BCA Assessment Report

1 Alexander & 4 Collaroy Street, Collaroy

Project: 1 Alexander & 4 Collaroy Street, Collaroy
Reference No: 112605-BCA-r1
Date: 29 October 2020
Client: Collaroy Street Pty Ltd
Client Contact: Antony Westwood
Email: antony@g-t.com.au
BCA Logic Contact: Jarryd Beckman
Direct: 8484 4094
Email: jbeckman@bcalogic.com.au

Revision	Date	Description	
112605-BCA-r1	29 October 2020	BCA Assessment Report (DA Stage)	
		Prepared by	Verified by
		Jarryd Beckman	Warwick Hunter
		Registered Certifier Grade A2, No. BDC 3126	Registered Certifier Grade A1, No. BDC 2417
		Building Regulations Consultant	Building Regulations Consultant

Figure 1 – Proposed compartmentation on the ground floor (FRL 120/120/120)

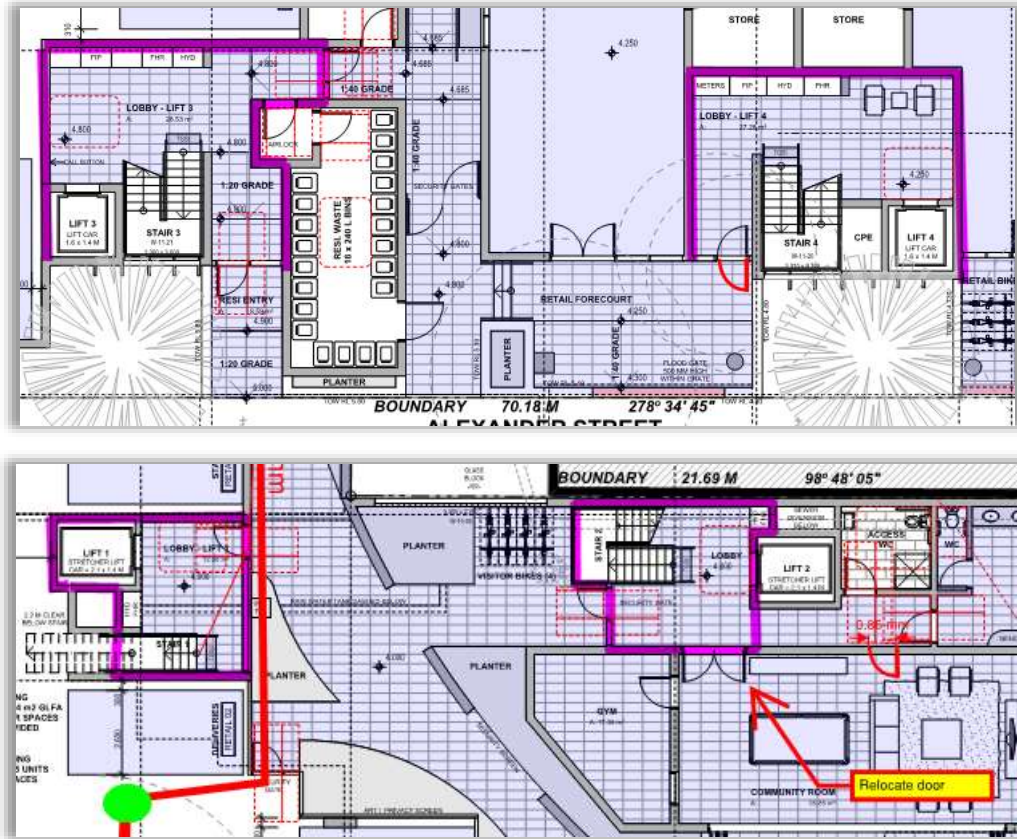
The building design involves direct connection between the basement, ground floor and upper residential level by virtue of the internal non-fire-isolated stairs. Therefore, to avoid the building being assessed as a large isolated building, all non-fire-stairs must be separated at the ground floor level by construction achieving an FRL of 120/120/120 (shown purple).

Where the stairs utilise glazed panels and/or doors, then a Fire Engineered performance solution will be required to allow Tyco Sprinklers to be installed on both sides of the glazing in lieu of the required 120/120/120 FRL.

Furthermore, it is recommended that discussions are held with a Fire Engineer to seek an additional solution to allow the fire rated walls to fall short of the construction edge on the southern elevations of Stair 3 & 4, subject to external sprinklers being installed adjacent to the entry doors in the forecourt and Resi entries.

Figure 2 – Sliding door openings within 3m of a fire source feature (side boundary)

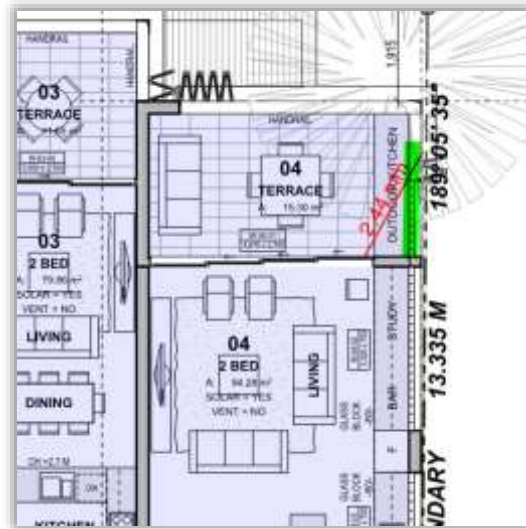
The sliding door openings that open onto the terrace areas of the northern building (all levels) will require protection by an FRL 30/- blade wall (shown green) to avoid the installation of external drenchers.

Figure 3 – Window openings within 3m of a fire source feature (side boundary)

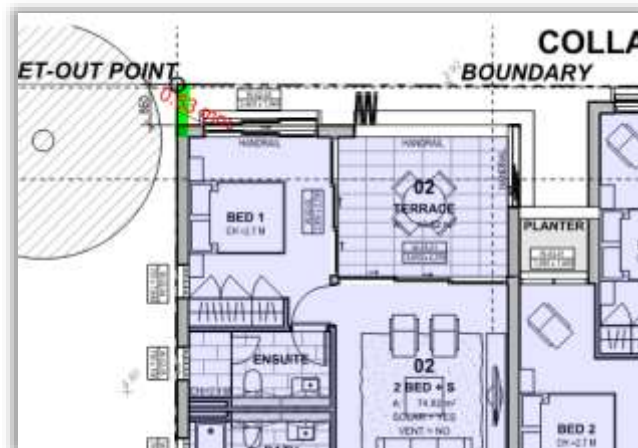
The northern window openings (adjacent to Collaroy Street – all levels) are located within 3m of the side boundary fire source feature and will require a blade wall with an FRL of 30/-/- to avoid the installation of a self-closing -/60/- fire shutter.

Figure 5 – Egress travel distances throughout the ground floor level carpark

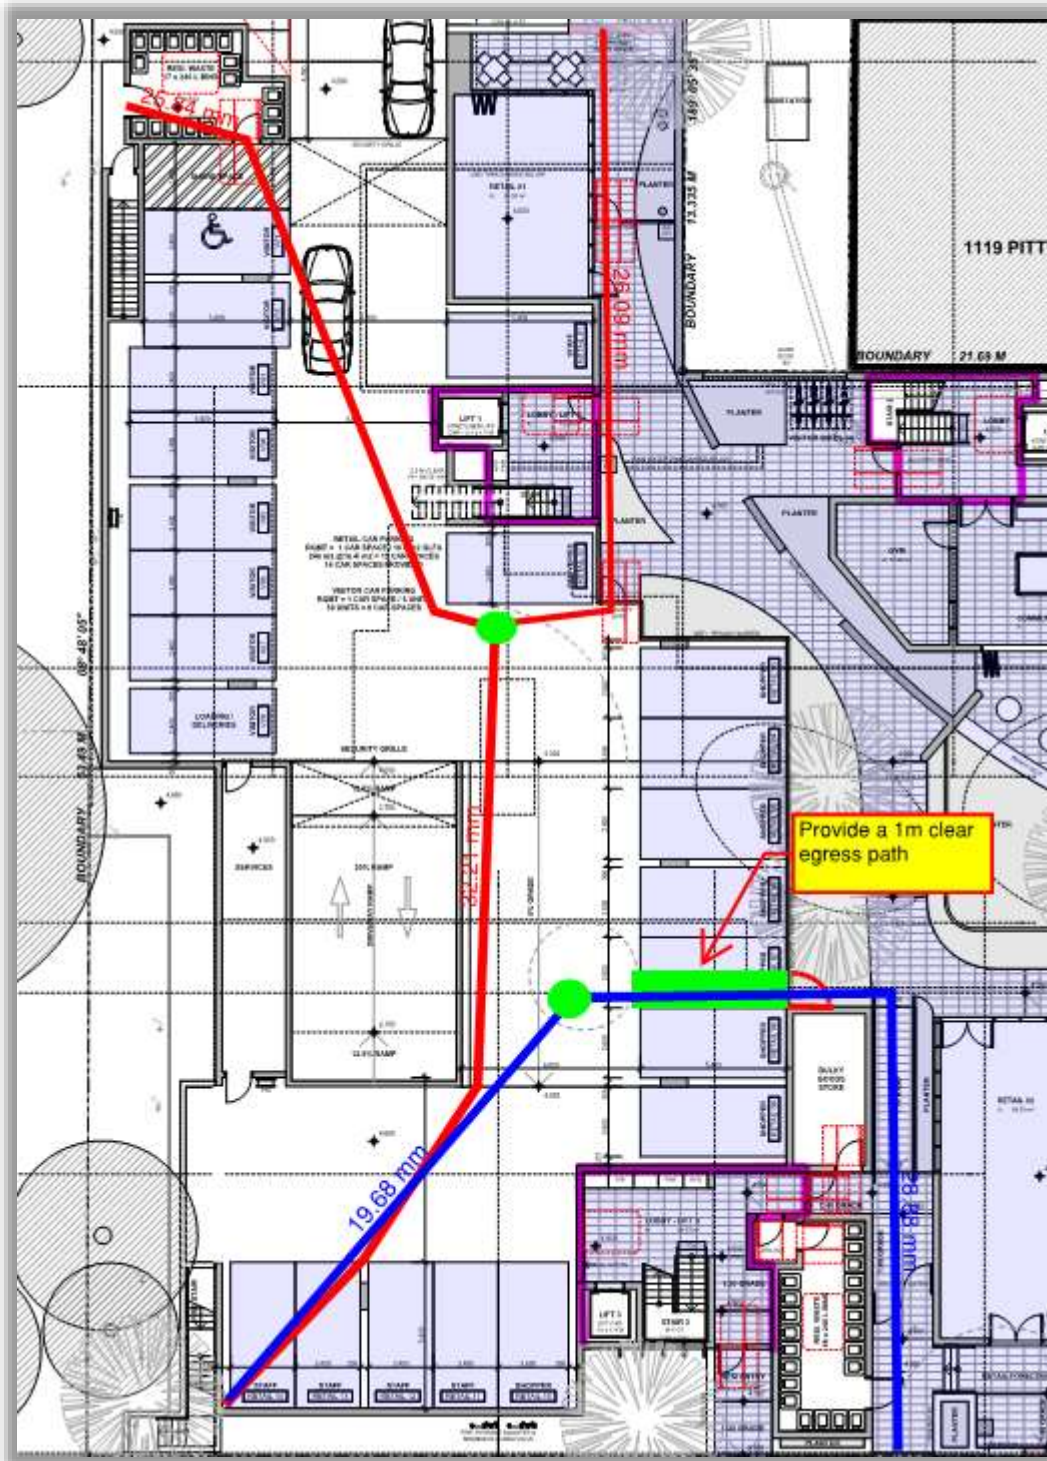
The ground floor level carpark has parts which are greater than 20m from a point of choice in which travel in different directions to two alternative exits is available, in which case the travel distance also exceeds the required 40m. The current travel distances (shown red) involve a distance of 32m to a point of choice and a further 26m to an exit (total distance 58m).

It is recommended that an additional egress path and exit door are installed adjacent to the bulky good store which will allow a point of choice to be located within 20m, although a fire engineered performance solution will still be required as the total travel distance is greater than 40m to an exit (shown blue).

Figure 7 – Exit door modifications

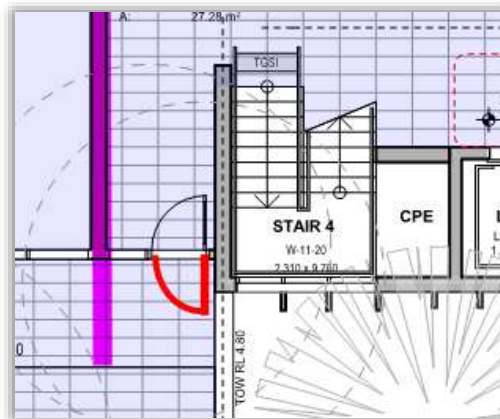
The final exit door at the base of Stair 4 must be modified and swing in the direction of egress (outwards).

Figure 8 – Proposed attack hydrant location (Collaroy Street)

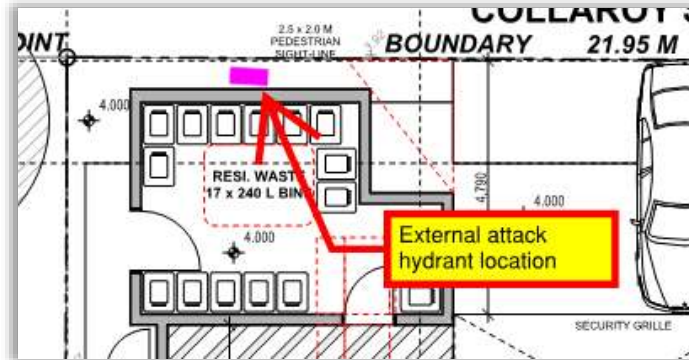
The ground floor level has internal hydrants located within 4m of the non-fire-isolated stairs, however coverage is not achieved throughout the carpark and retail areas. An additional external attack hydrant

must be installed on Collaroy Street (adjacent to the residential waste room) as well as an attack hydrant fitted into the booster assembly on Alexander Street.

Figure 10 – Grated drain and step-down methods in accordance with AS 4654.2

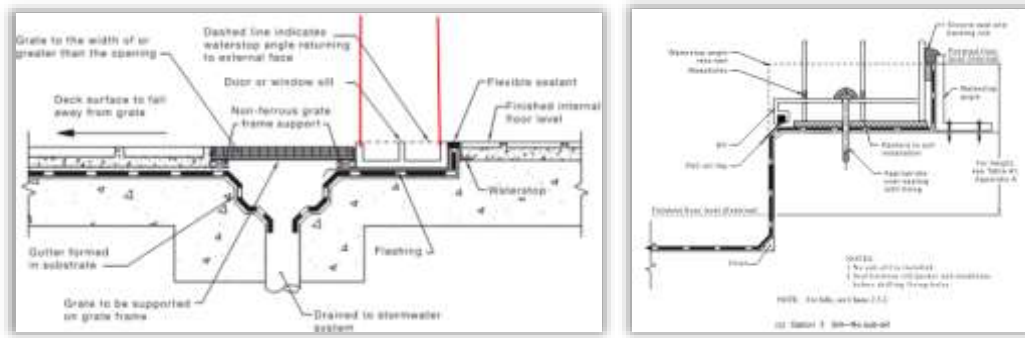
The external balconies, terraces and common areas will require a waterproofing membrane in accordance with AS 4654.1 & .2. Further information will be required during design development to ensure there is a step down or grated drain installed at the door thresholds which leads onto the external above ground membrane.

Note: where disabled access is required, a grated drain will be required in lieu of a step down.
